ADDENDUM NUMBER 02 (REVISED)

DATE: January 23, 2024

PROJECT: Cass District Library Edwardsburg, MI

PROJECT NUMBER: 22-1836

C1.0

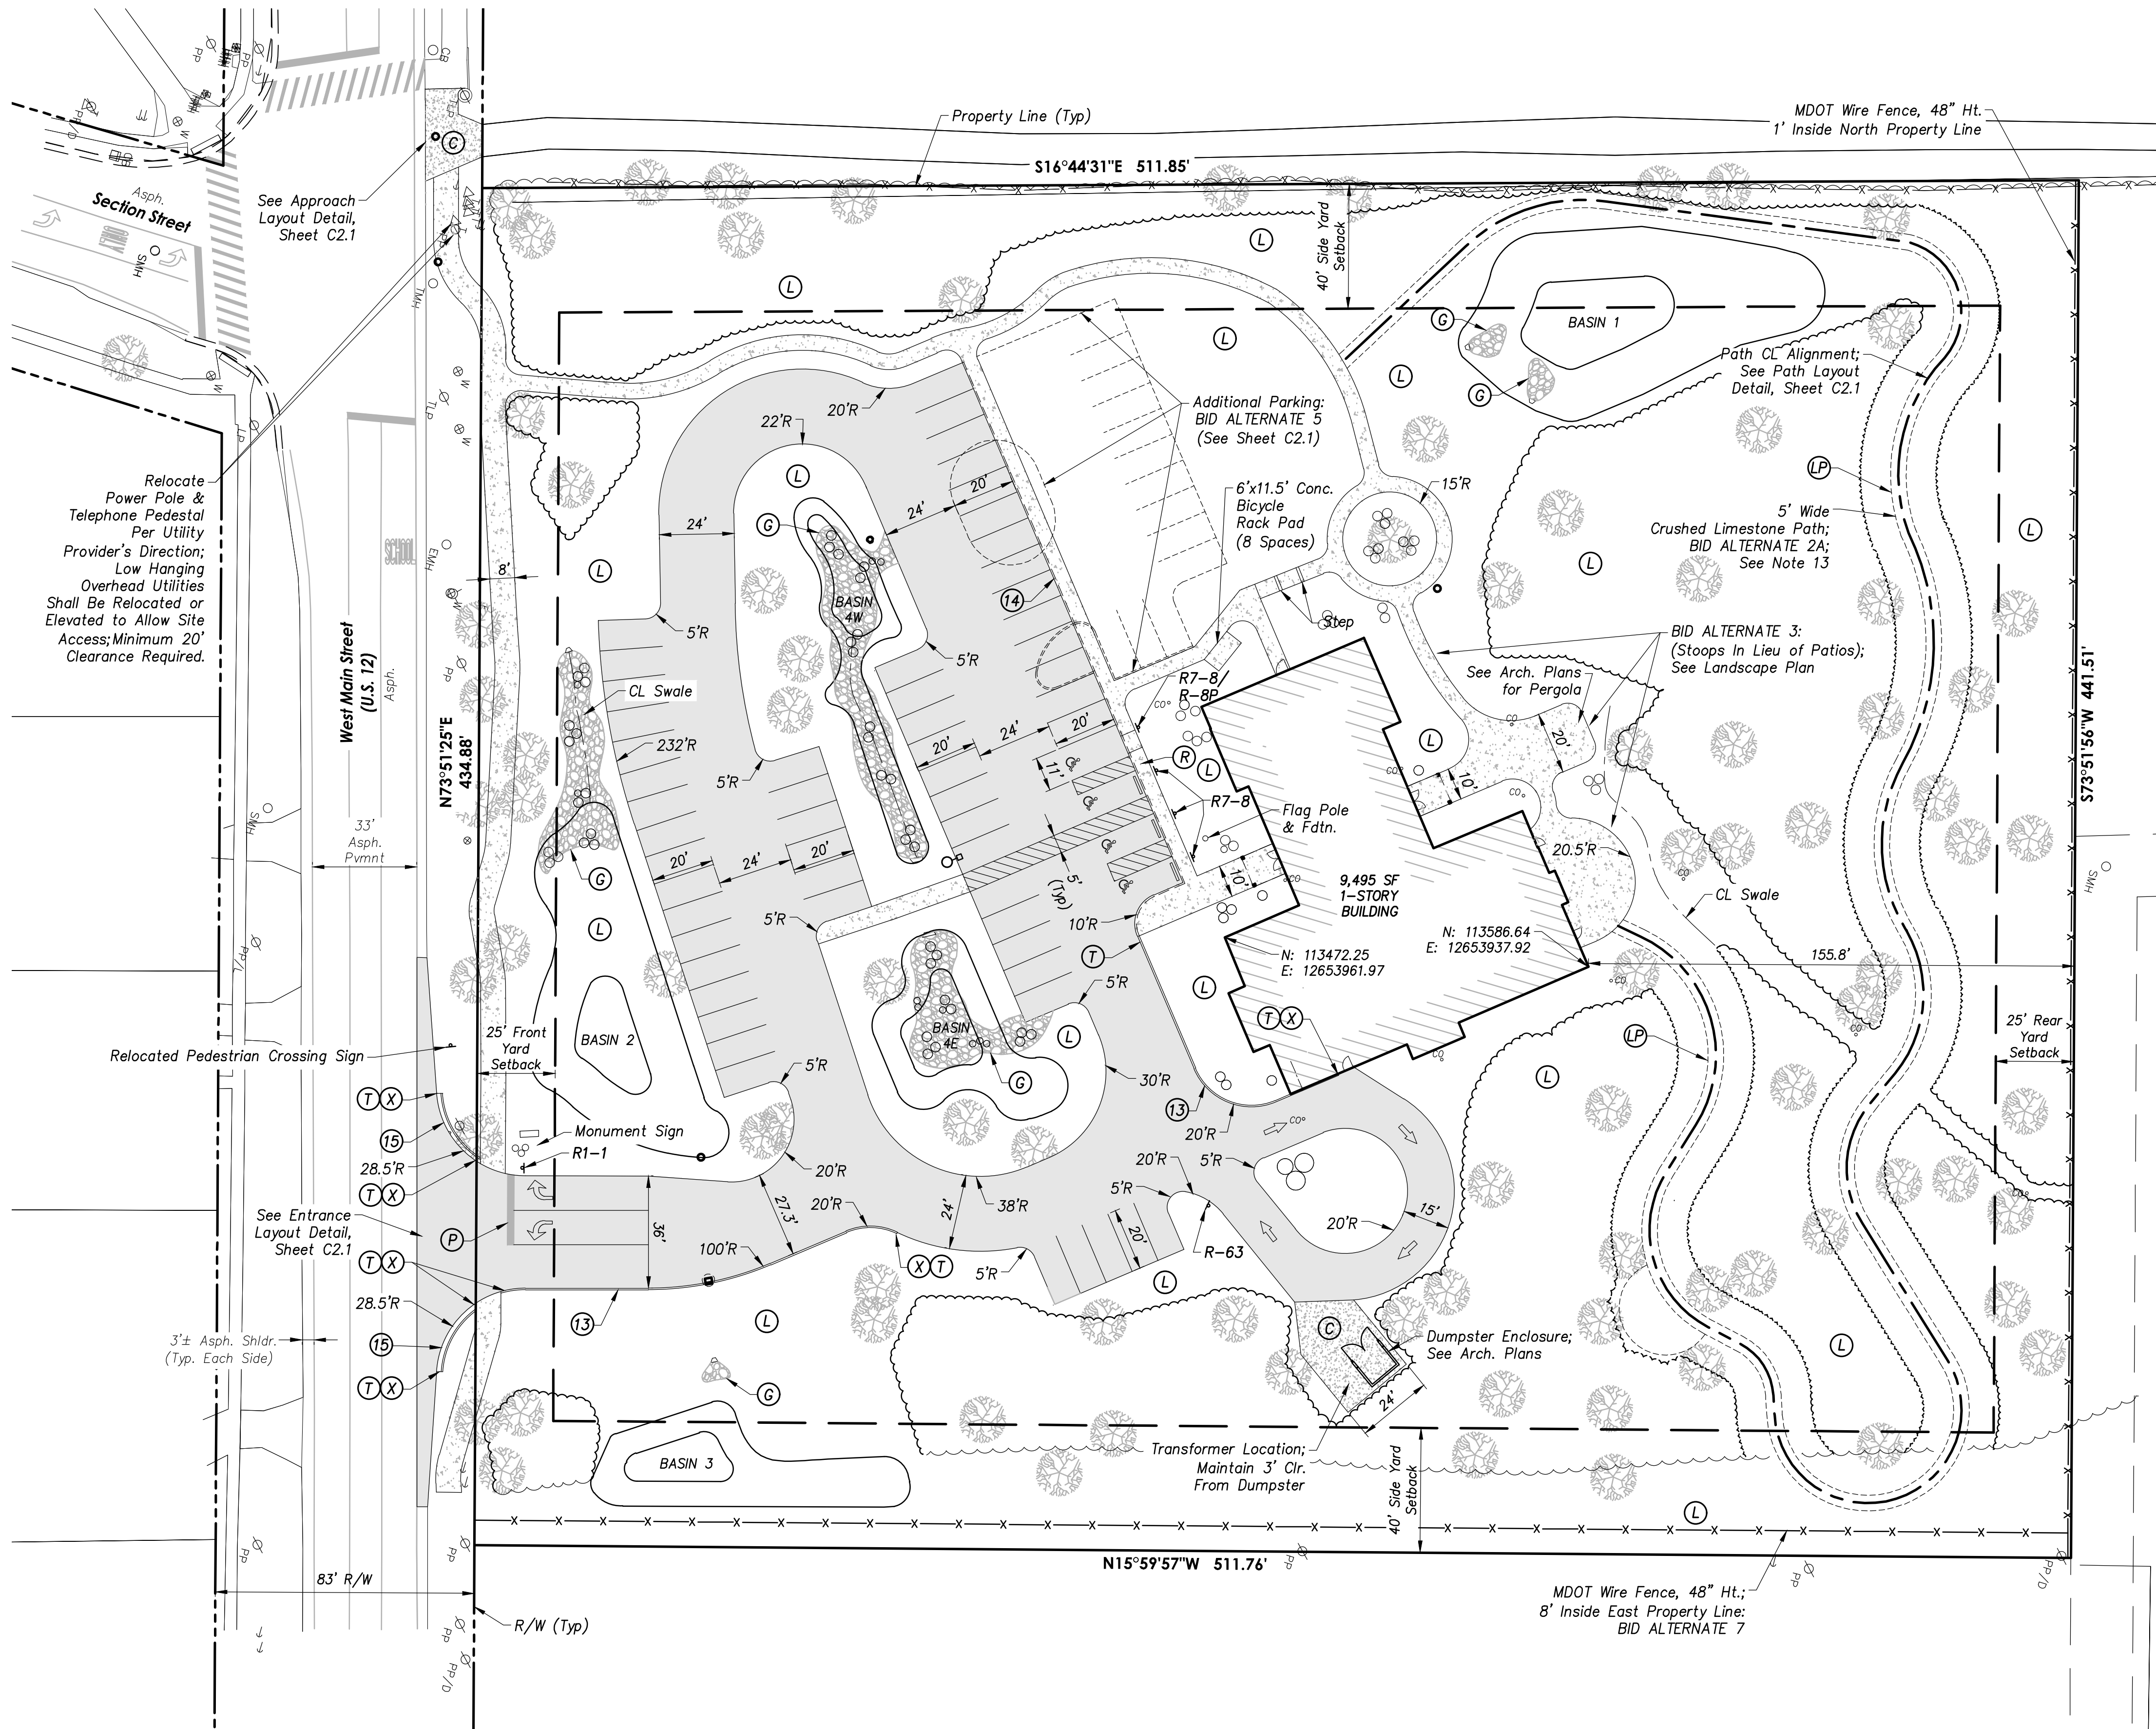
DRAWING C1.0 – EXISTING CONDITIONS & DEMOLITION PLAN (Re-Issued)

18. **REVISE** Topographic Information.
19. **REVISE** Horizontal Datum

8  
S2.1 BOLLARD DETAIL  
1" = 1'-0"

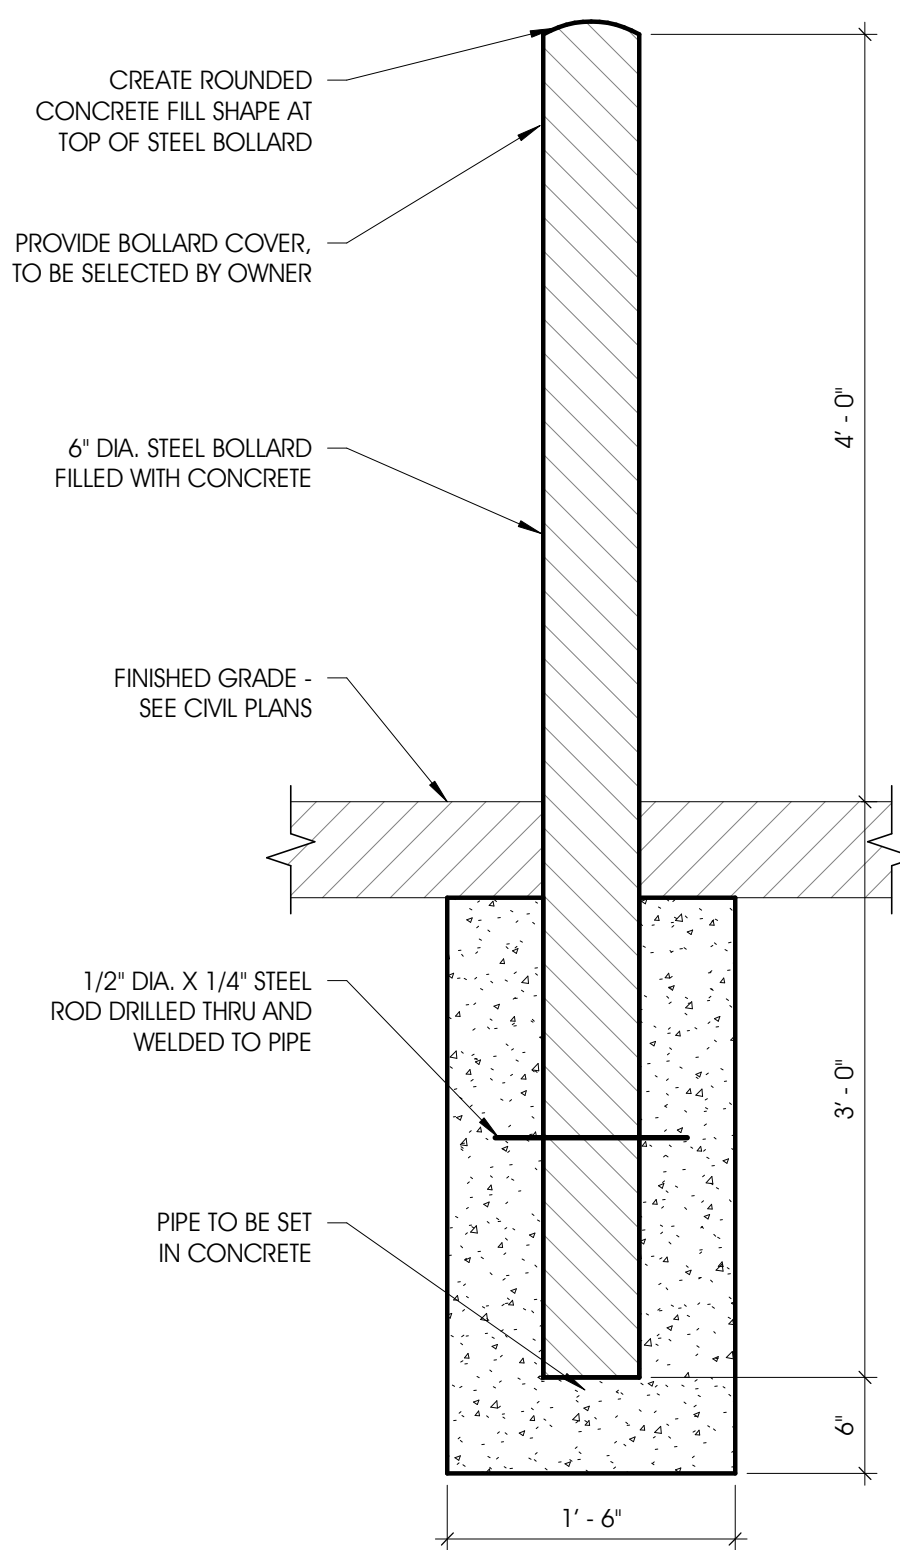
- 118.** Sheet S2.1 detail 8 indicates the use of both a bollard cover and painting as a finish. Sheet A7.6 dumpster enclosure note f states using yellow bollard covers. Please clarify if bollards are to receive covers or to be painted finish.

- a.** Please see revised sheet S2.1 detail #8 and sheet A7.5 note "F". Bollard cover shall have pvc slip on yellow covers. Delete painted finish requirement.

7  
S2.1 FOUNDATION DETAIL @ ENCLOSED DUMPSTER  
1" = 1'-0"

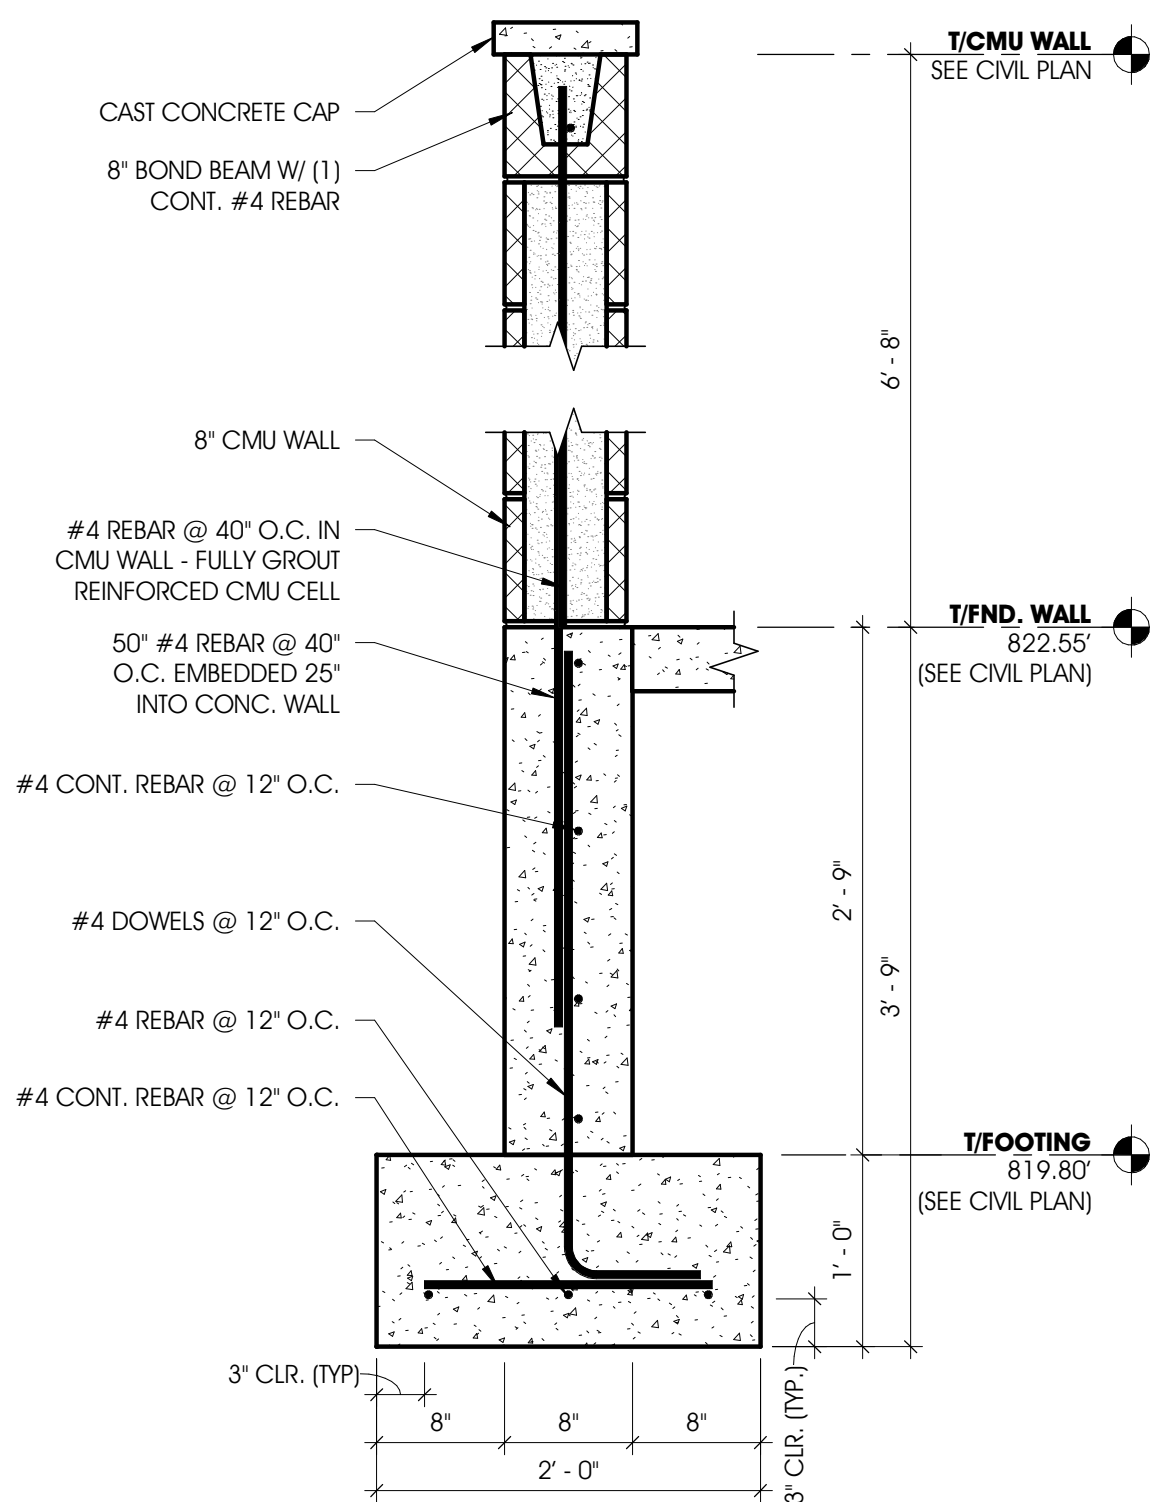
- 35. REVISE** Detail #7, #8, & #9 – Footing Sizes

8 FOUNDATION DETAIL  
S2.3 1" = 1'-0"

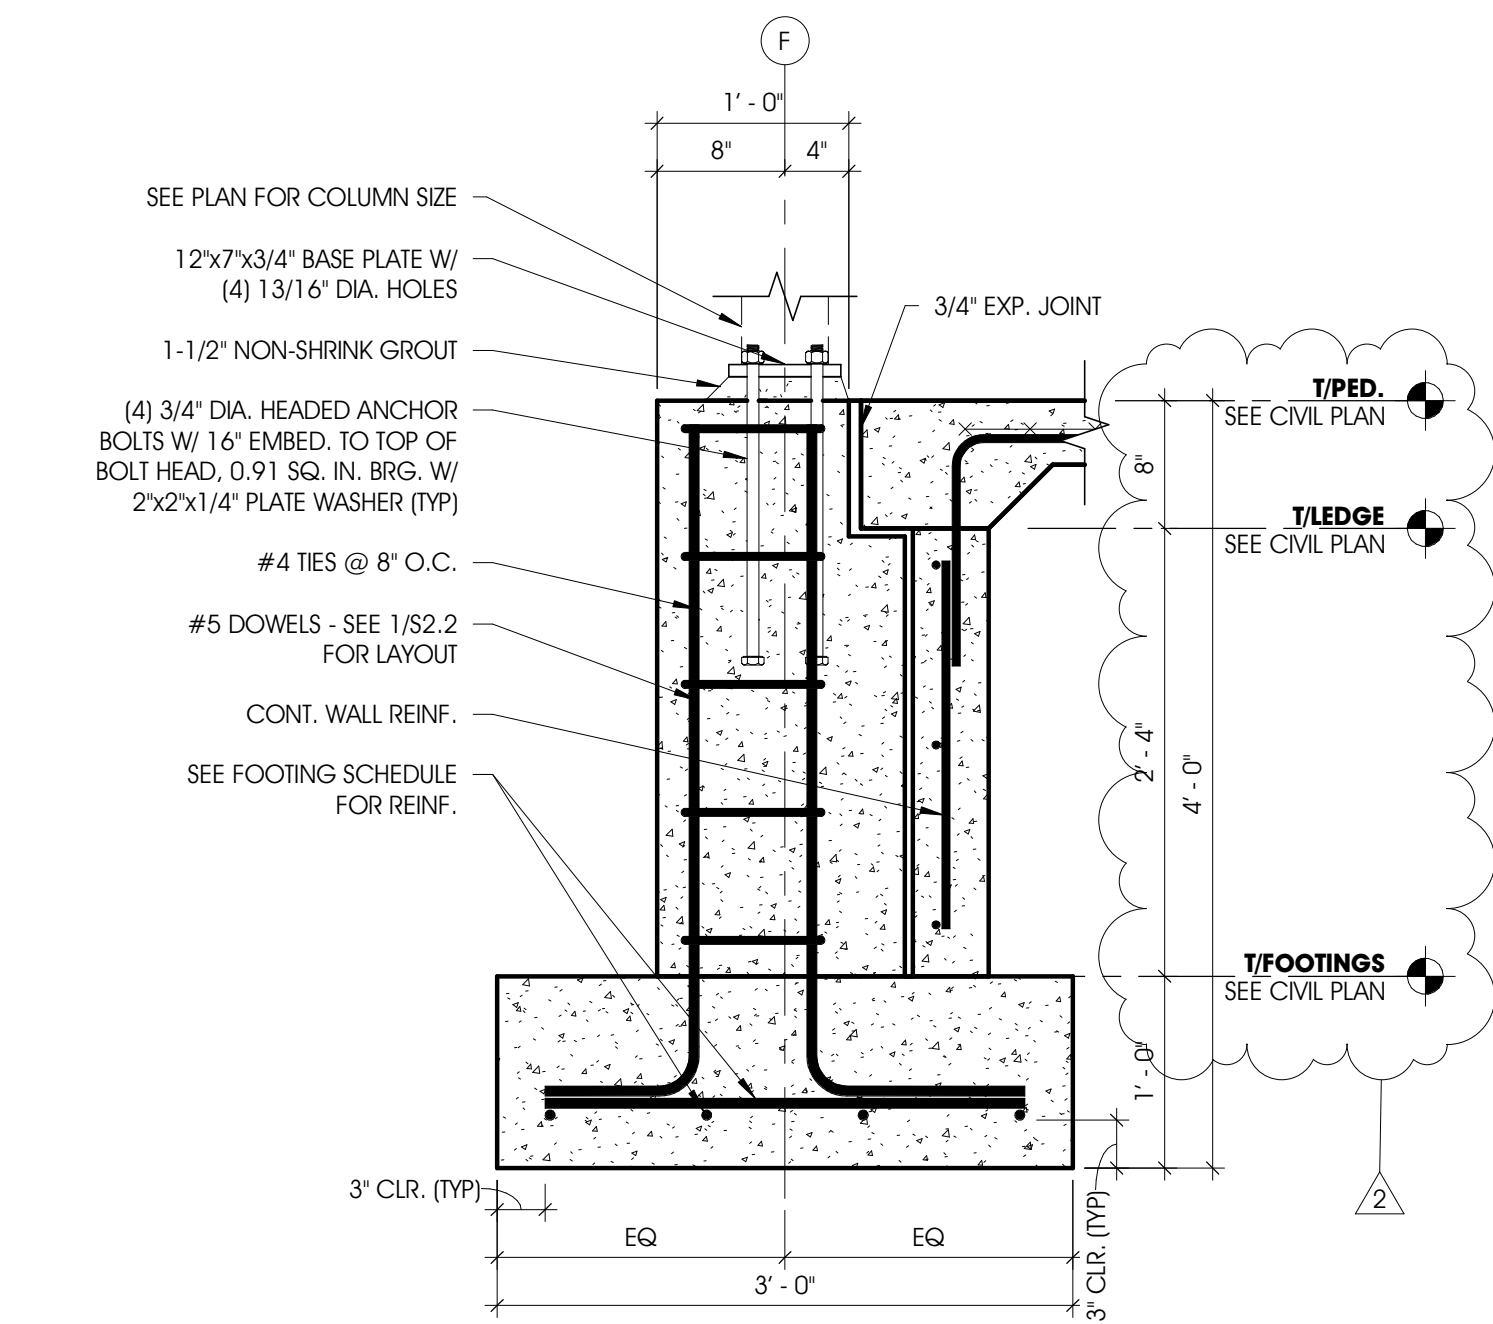
- 37. REVISE** Detail #8 For Adjusted Foundation Footing Depth
